ADDENDUM NO. 4

RE: ADA Improvements To
Hartley Job Administration Building
Project No. 11-0416

OWNER: Michigan City Port Authority
200 Heisman Harbor Drive
Michigan City, IN 46360

This Addendum is intended to clarify/revise the plans and specifications per the following items:

M1.1

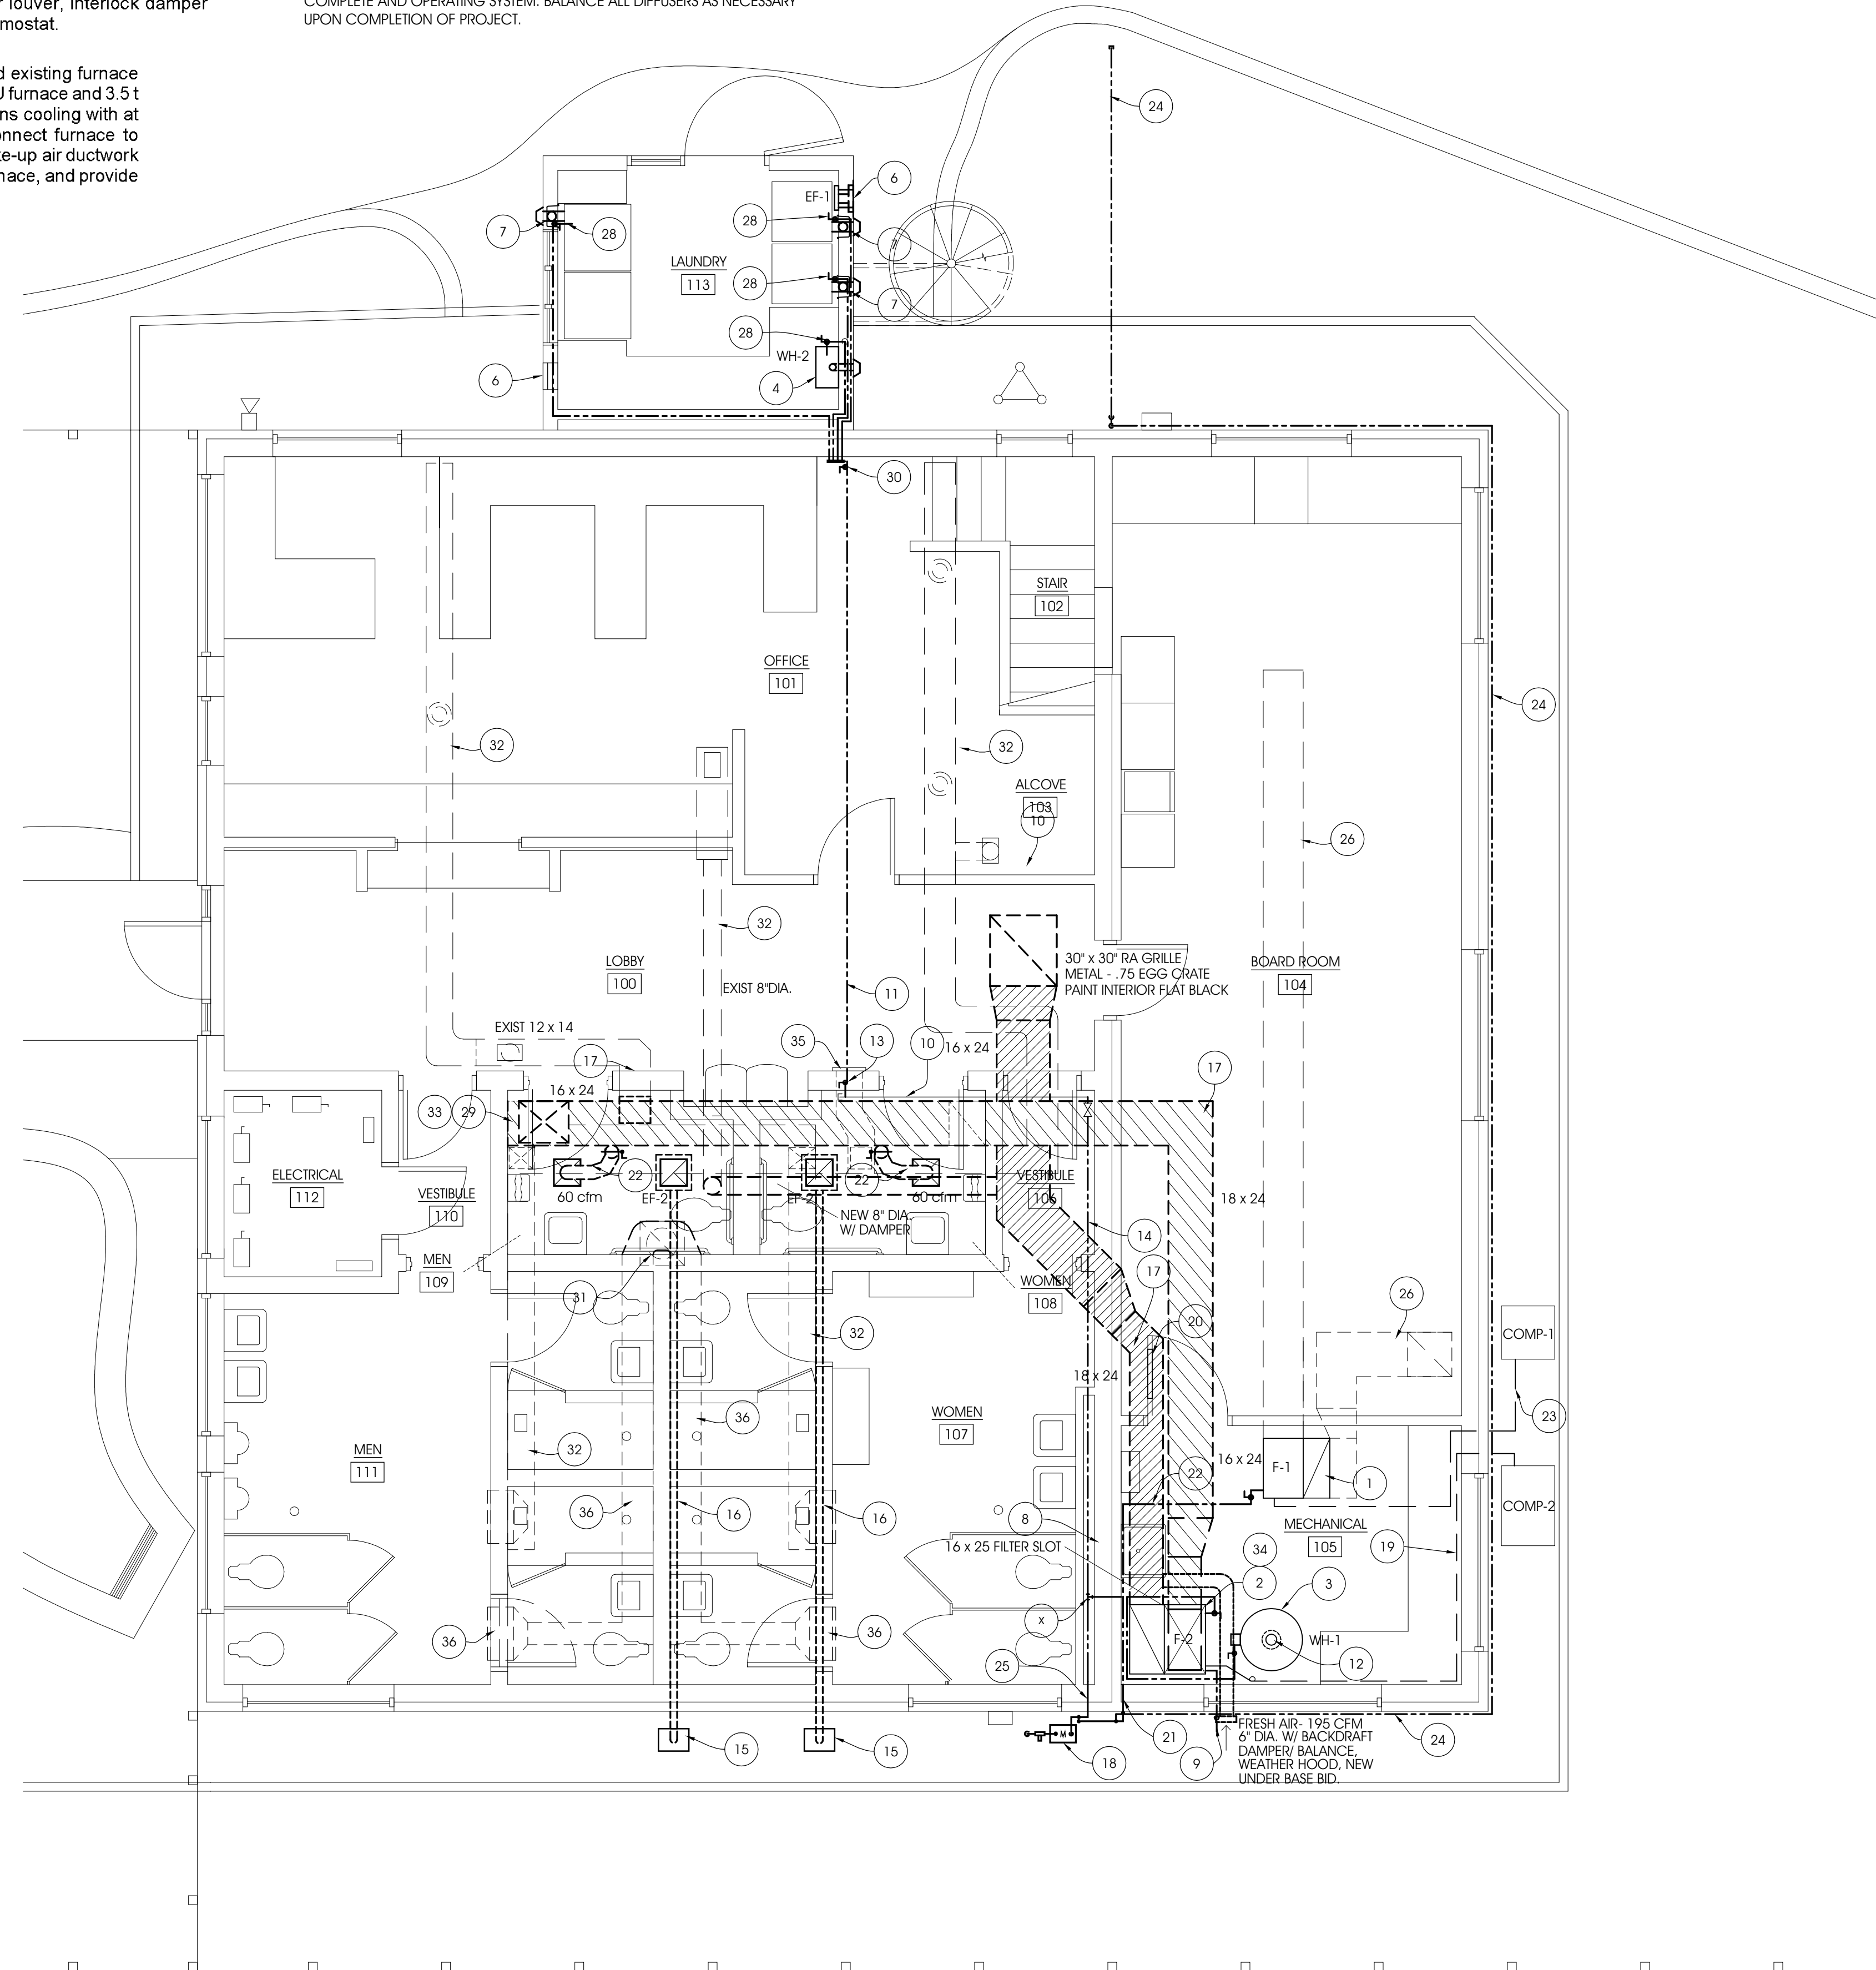
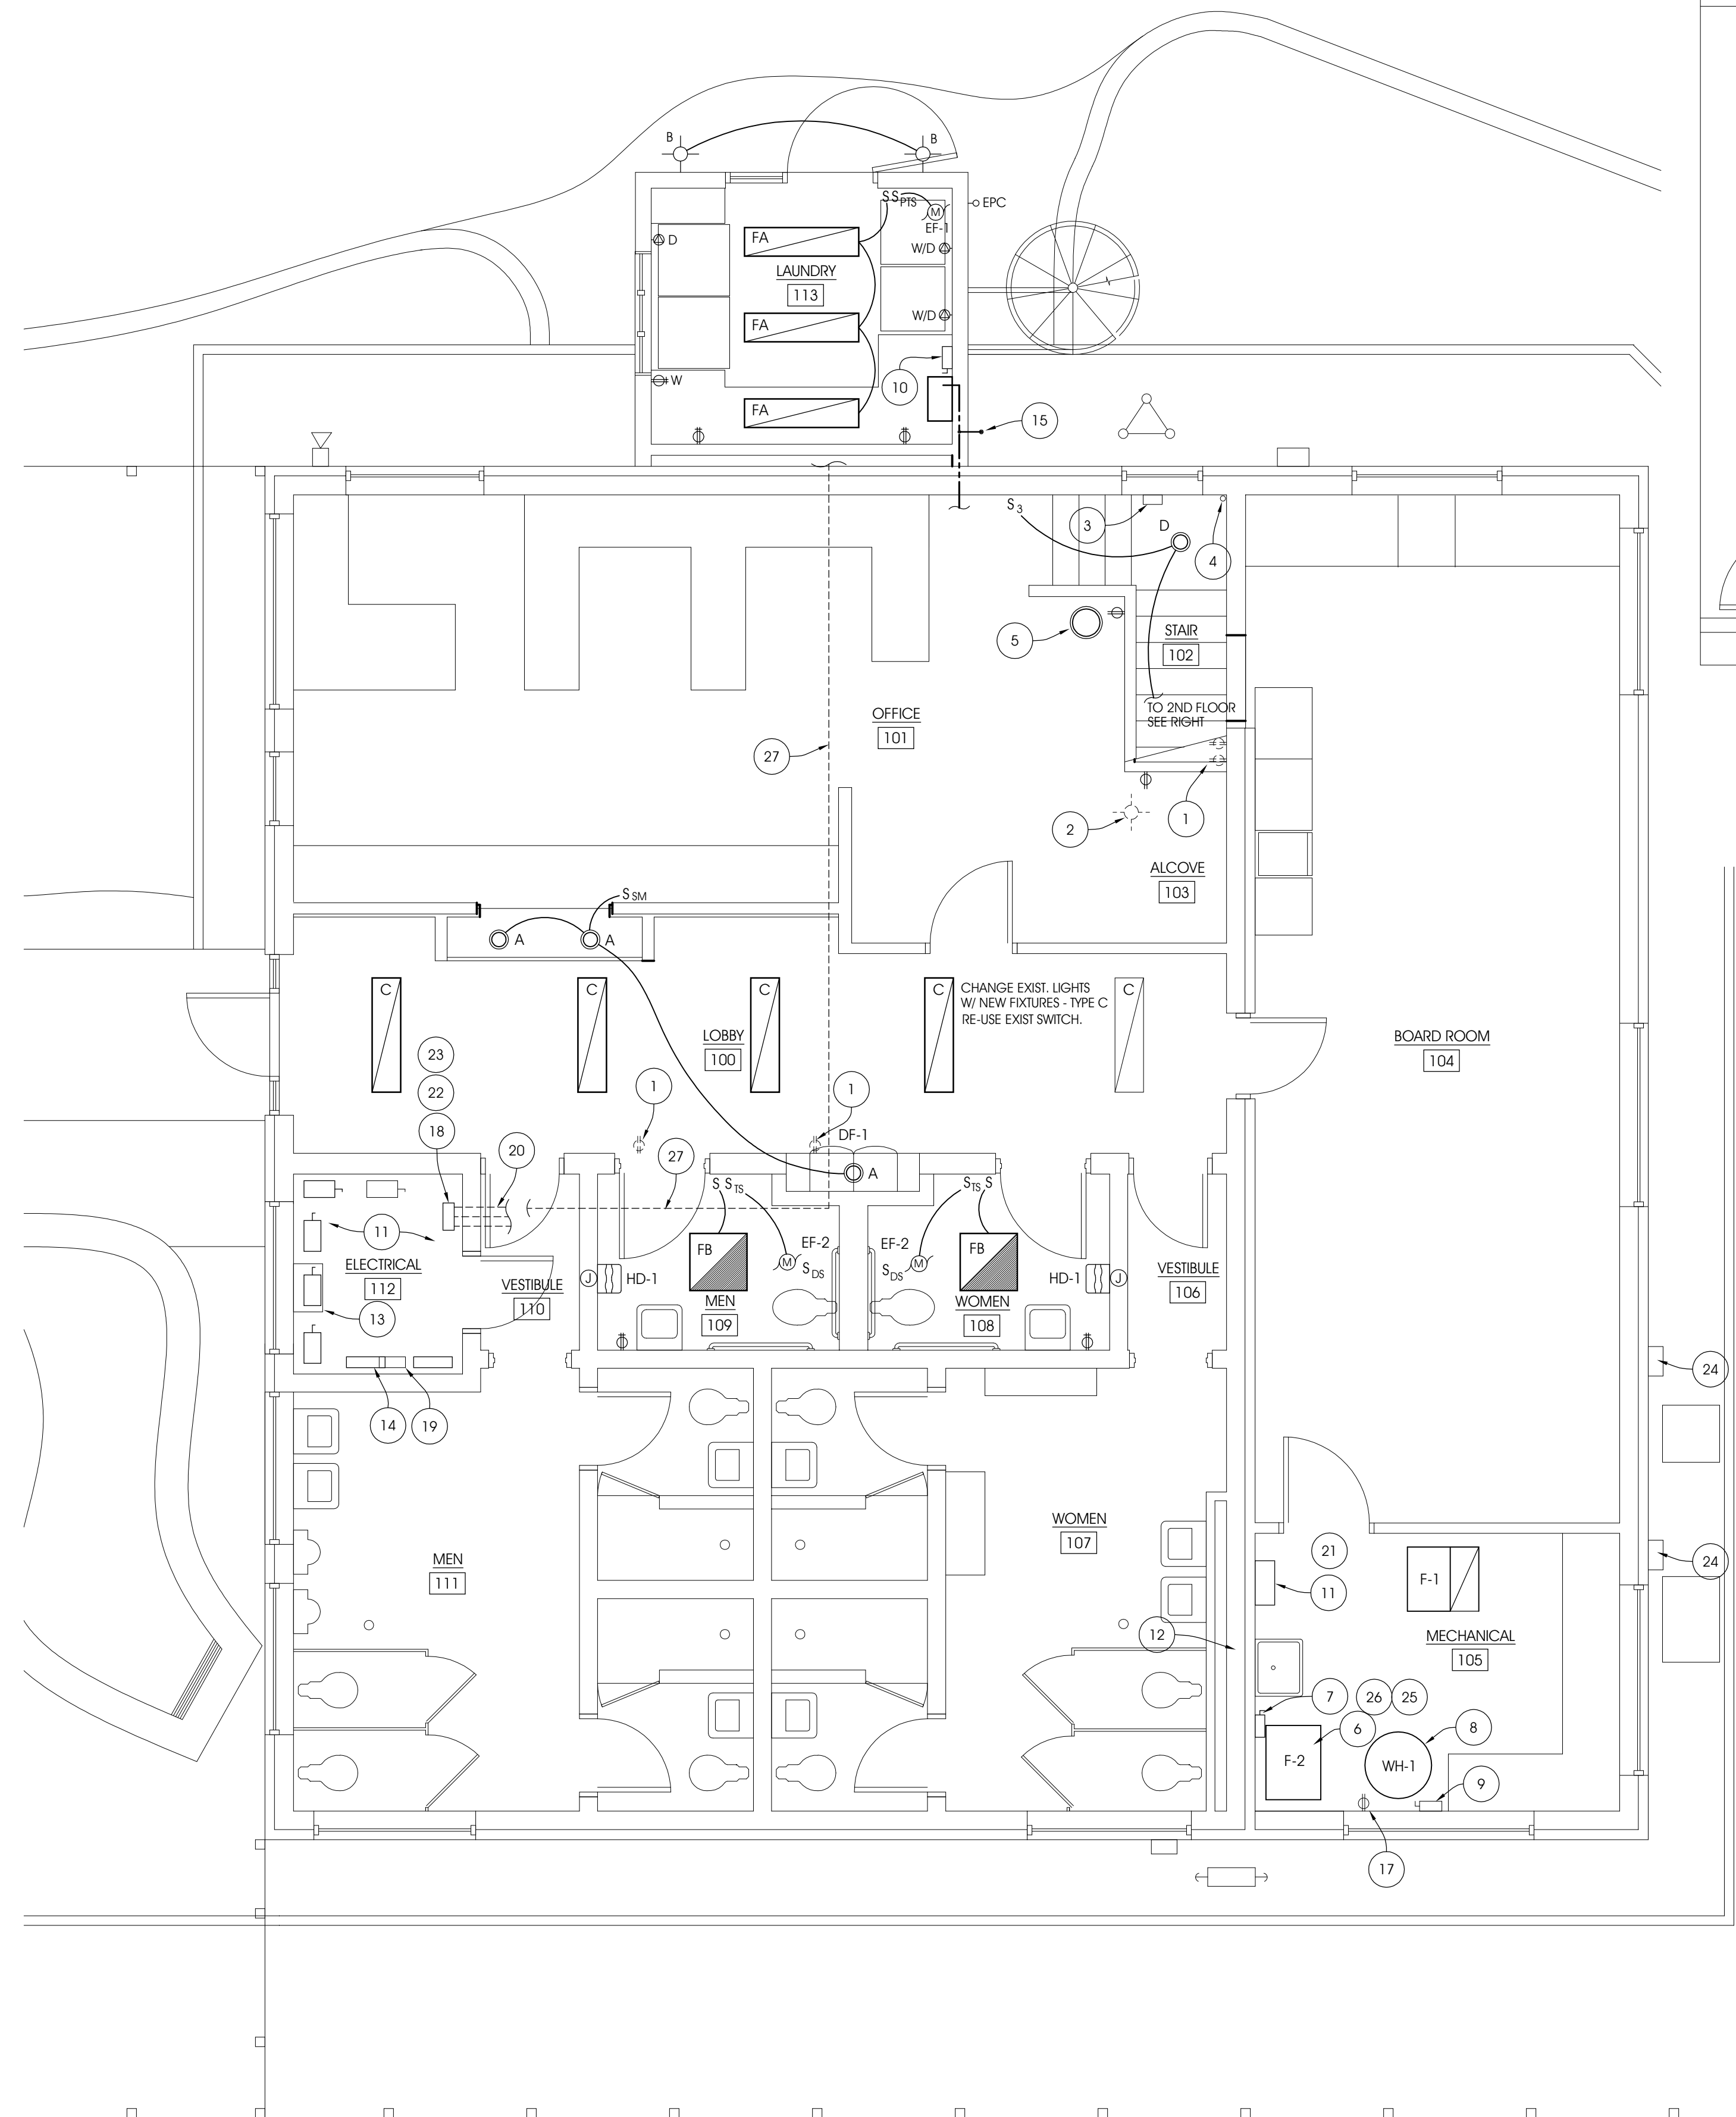
ITEM 3 SHEET M1.1 Addendum No. 2: Add keynotes 22 through 36, add routing of ductwork graphics, Base Bid Notes, BTU change to furnace size in Alternate No. A-2, gas line changes to Laundry Room, and added keynote changes from Addendum No. 3.

22. EXISTING 1/2" GAS LINE EXPOSED ON CEILING TO REMAIN.
23. EXISTING CONDENSATE LINE TO COMPRESSOR TO REMAIN.
24. EXISTING 1/2" EXPOSED GAS LINE TO PATIO GRILLE TO REMAIN.

25. EXISTING 2" GAS LINE TO BUILDING.
26. EXISTING BOARD ROOM MAIN SUPPLY & RETURN DUCT TRUNK LOCATED ABOVE THE CEILING WITHIN ATTIC SPACE. ALL DUCTWORK, SUPPLY DIFFUSERS, AND RETURN GRILLES TO REMAIN.

27. TIE NEW 3/4" GAS LINE INTO EXISTING 2" SUPPLY LINE.
28. NEW SHUT-OFF VALVE AND 3/4" CSST GAS TUBING WITH JACKET.
29. TIE EXISTING DUCTWORK INTO NEW SUPPLY DUCT LOCATED UP IN ATTIC. EXTEND EXISTING DUCTWORK BRANCHES AS REQUIRED. SEAL AROUND DUCT PENETRATIONS WITH DUCT SEALANT.

30. NEW 2" GAS SHUT-OFF VALVE. CAST IRON HEADER WITH 4 - 3/4" BRANCH FEEDS TO WATER HEATER, AND 3 GAS DRYERS.
31. EXISTING ROOF MOUNTED EXHAUST FAN AND DUCTWORK TO REMAIN.

32. EXISTING SUPPLY DUCTWORK AND DIFFUSERS TO REMAIN.
33. PATCH FORMER DUCT OPENING IN EXISTING WOOD DECK WITH NEW 22 GA. SHEET METAL PATCH, SET IN SEALANT BED AND FASTEN WITH WASHERS AND SHEET METAL SCREWS AT 6" O.C. AROUND OPENING. AT ANY FORMER DUCT OPENING WITHIN BLOCK, IN-FILL WITH MASONRY AND GROUT-IN FULL AS REQUIRED.

34. 6" DIAMETER FRESH-AIR INTAKE DUCT (195) TIED BACK TO MAIN RETURN AIR DUCT. PROVIDE IN-TAKE WITH LOW VOLTAGE MOTORIZED DAMPER, BALANCING DAMPER AND WEATHER HOOD THRU EXTERIOR MASONRY WALL. SEAL AROUND ALL PENETRATIONS AND INSULATE ENTIRE DUCT RUN WITH 3" FIBERGLASS WRAP AND SEAL WITH FOIL FACING. TAPE ALL JOINTS AND SEAL. INSTALL THIS WORK UNDER BASE BID & ALTERNATES A-1, A-2.

35. EXISTING WALL GRILLE AND SUPPLY DUCT TO REMAIN.
36. EXISTING EXHAUST DUCTWORK AND GRILLES TO REMAIN.
